County of Santa Cruz

DEPARTMENT OF PUBLIC WORKS

SUBJECT: REVISION TO THE OPEN TRENCH BACKFILL REQUIREMENT

LONGITUDINAL TRENCH DETAIL

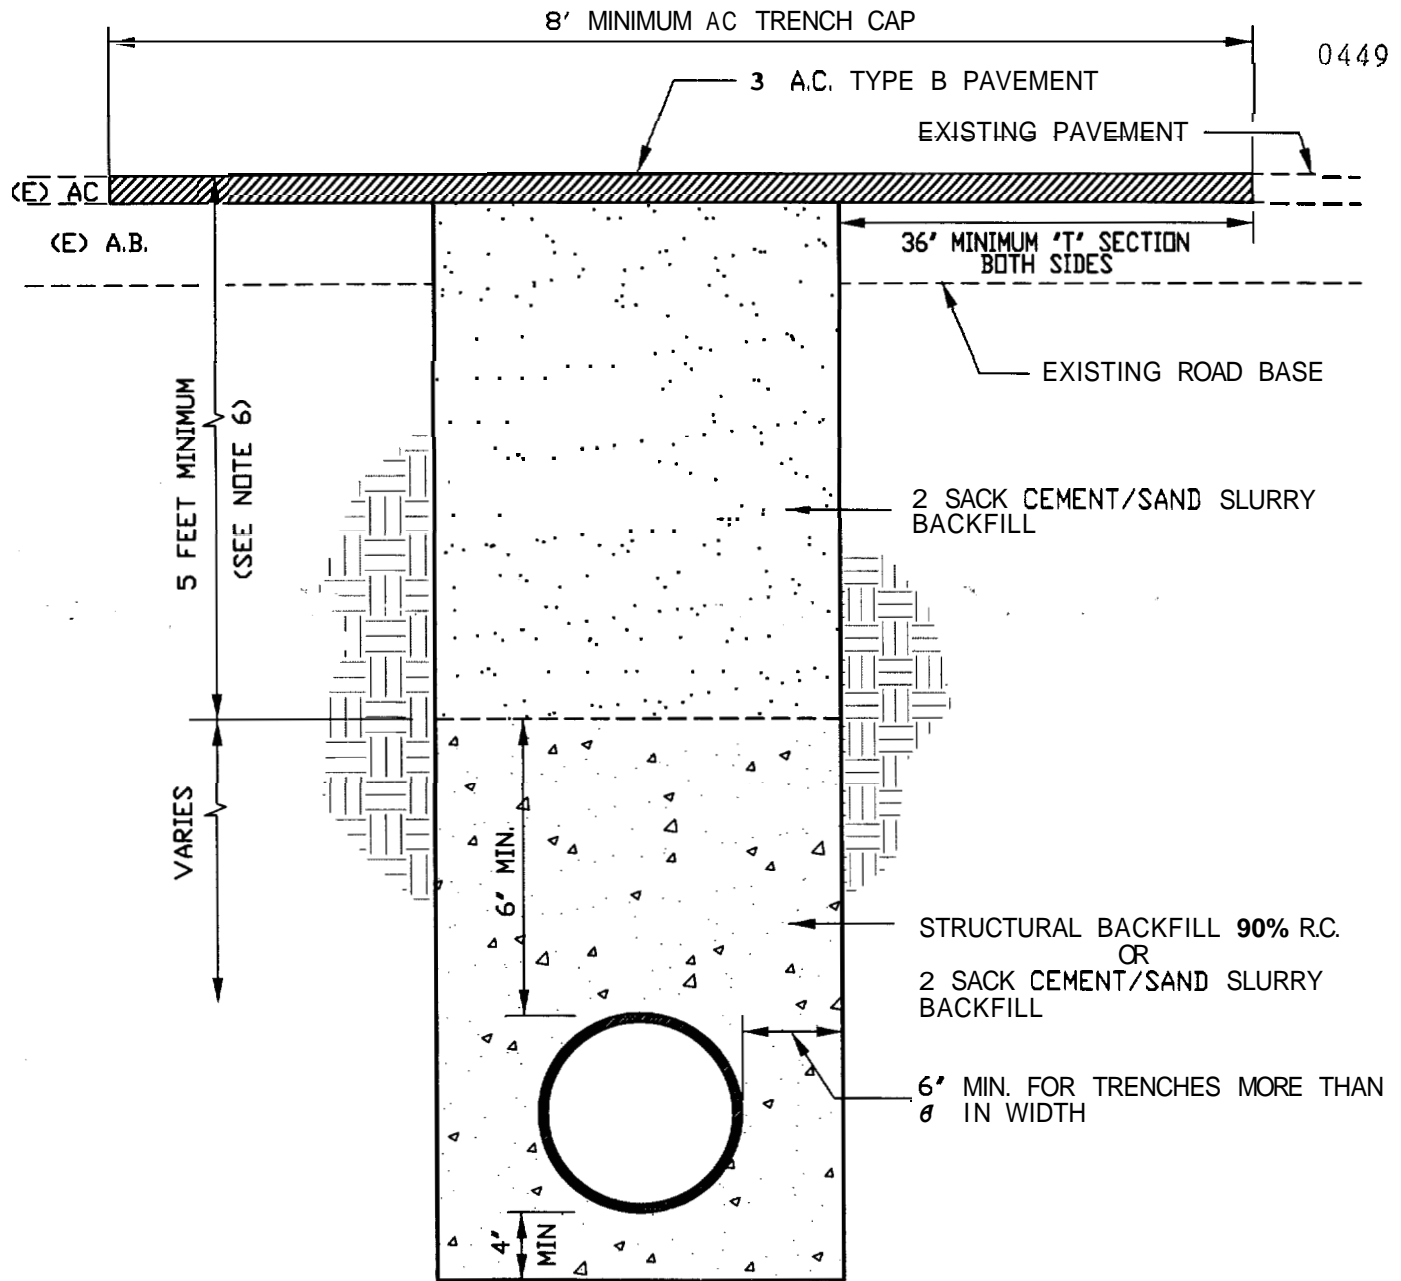
Attached for your consideration and approval are the proposed revisions to the longitudinal and cross trench details in the County Design Criteria. These changes include a minimum trench cap of eight feet and an increased minimum "T" section of **36** inches for cross trenches and 24 inches for longitudinal trenches. These changes are intended to encourage utilities to combine their facilities in a joint trench. It will also reduce the "speed bump" effect from multiple narrow cross trenches.
